AGENDA
SPECIAL MEETING
LA PUENTE PLANNING COMMISSION AND
DEVELOPMENT REVIEW BOARD
CITY HALL COUNCIL CHAMBERS
15900 E. MAIN STREET, LA PUENTE
January 12, 2012
7:00 P.M.

2. **SIGN PLAN APPLICATION NO. 1093 –** Consideration of a resolution approving a Sign Plan Application for a Master Sign Program for a commercial development located at 1255-1313 N. Hacienda Boulevard and 15125, 15217, 15225 Fairgrove Avenue La Puente, California.

From: Beth Chow, Assistant Planner Date: January 5, 2011

SUBJECT: SIGN PLAN APPLICATION NO. 1093
1255-1313 N. Hacienda Boulevard
15125, 15217, 15225 Fairgrove Avenue
(Jasmine Real Estate Investments, LLC)

Exhibit C – Proposed Monument Signs – Location B.1 & B.2

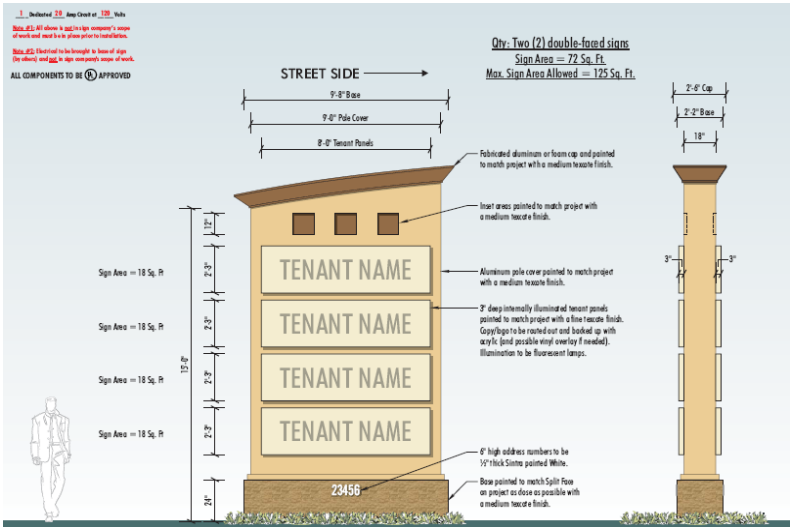
The Applicant has proposed three freestanding signs along the entrances fronting onto Hacienda Boulevard. In all cases, the freestanding signs must be a minimum of 5 feet away from the public right of way as required by LPMC §10.74.080(a)(1)(B). A condition of approval has been added to the resolution to reflect that all free-standing signs meet the minimum distance from the

public right of way. All proposed signs are highlighted with a split face base that incorporates the Property's address, and include spaces for tenant identification, which will be internally illuminated. Above the lettering, there will be inset areas acting as decorative elements, and a slanted cap for the sign, which will be painted to match the trim colors of the development. Staff is recommending, and the Applicant has agreed, to include the planting of annuals to better highlight the signs. A condition of approval to this effect has been included in the resolution.

Exhibit D – Proposed Pylon Sign – Location A.1

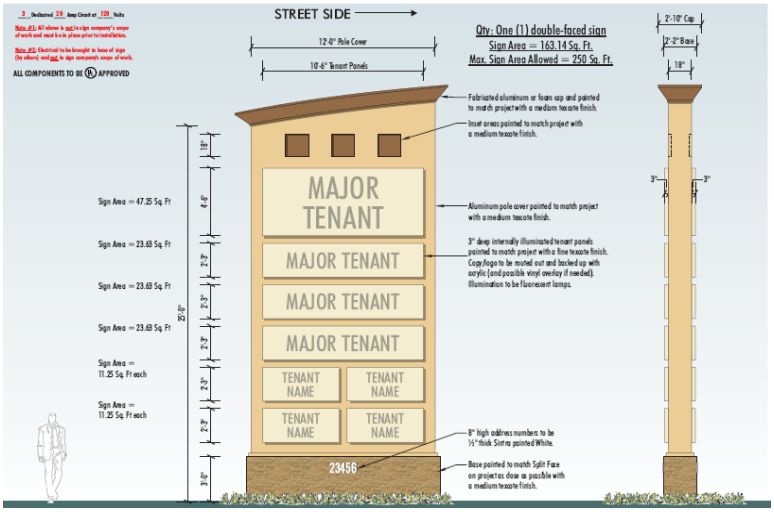
There are two different sizes for the proposed free-standing signs. The two (2) smaller signs will be at the north-most and south-most drive entrances along Hacienda Boulevard, while the largest sign is proposed adjacent to the middle drive entrance. All three (3) will be double faced. The two smaller signs are monument signs that are 75 square feet in area and have a maximum height of 15 feet. These two signs will also feature 6" high address numbers to help in way-finding. The largest sign will be a pylon sign with 163.14 square feet in sign area and will have a height of 25 feet, which will contain 8" high address numbers.

Exhibit E – Proposed Directory Sign – Locations C.1 & C.2

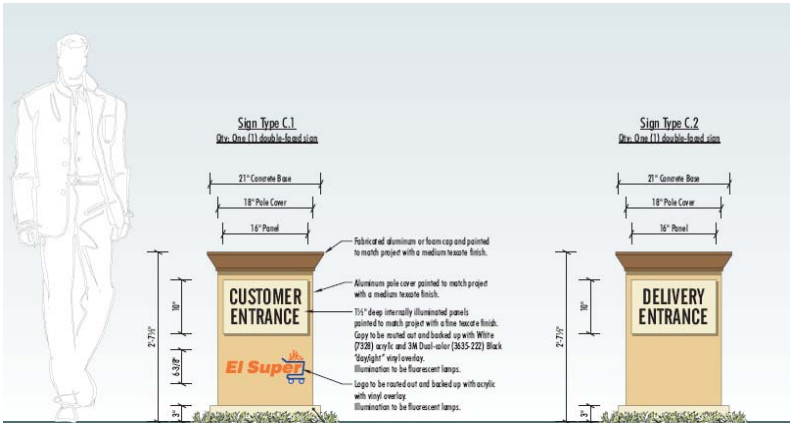
The Applicant has proposed two (2) directional signs along Fairgrove Avenue. Directional signs are allowed in all zones, but are limited by height, area, and distance from the public right of way. The directional signs indicate a customer entrance, as well as a delivery entrance. The signs must be located at least 5' from the public right of way. The proposed height of 2'7½" and the proposed area of 1 square feet comply with LPMC § 10.74.060(d). The two signs will be placed near the drive entrances along Fairgrove Avenue, with the western most driveway for delivery entrances and eastern most driveway for customers.

Figure 1: Approved Freestanding Sign (1990)

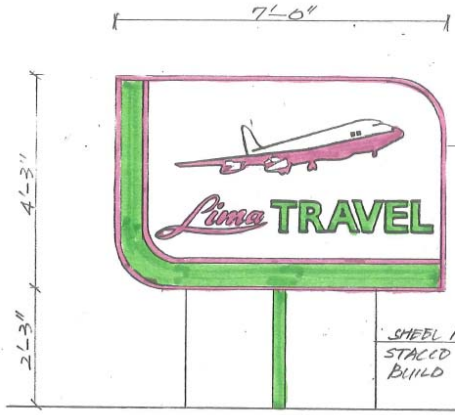
The development currently has one (1) existing freestanding sign. This monument sign was approved in 1990 and measures approximately 30 square feet in sign area with a height of 6'6". However, there have been subsequent additions to the sign with a box sign that measures approximately 1'6" high and 7' wide. This brings the total sign area to 56 square feet in area and with a height of 8'. Generally, properties of this size are allowed only one (1) monument sign, up to 8 feet in height and 50 square feet in area. However, the LPMC allows the Development Review Board greater flexibility in regards to sign area. It is Staff's opinion that the existing sign is of a size and scale that is compatible with the property. However, the top portion of sign was not permitted previously, and would still require building permits. Staff recommends that the Applicant be allowed to legalize the sign to its current configuration, complying with all Building Department regulations. A condition of approval has been added to the resolution to address the unpermitted portion of the freestanding sign. No additional freestanding signage is proposed for the site.
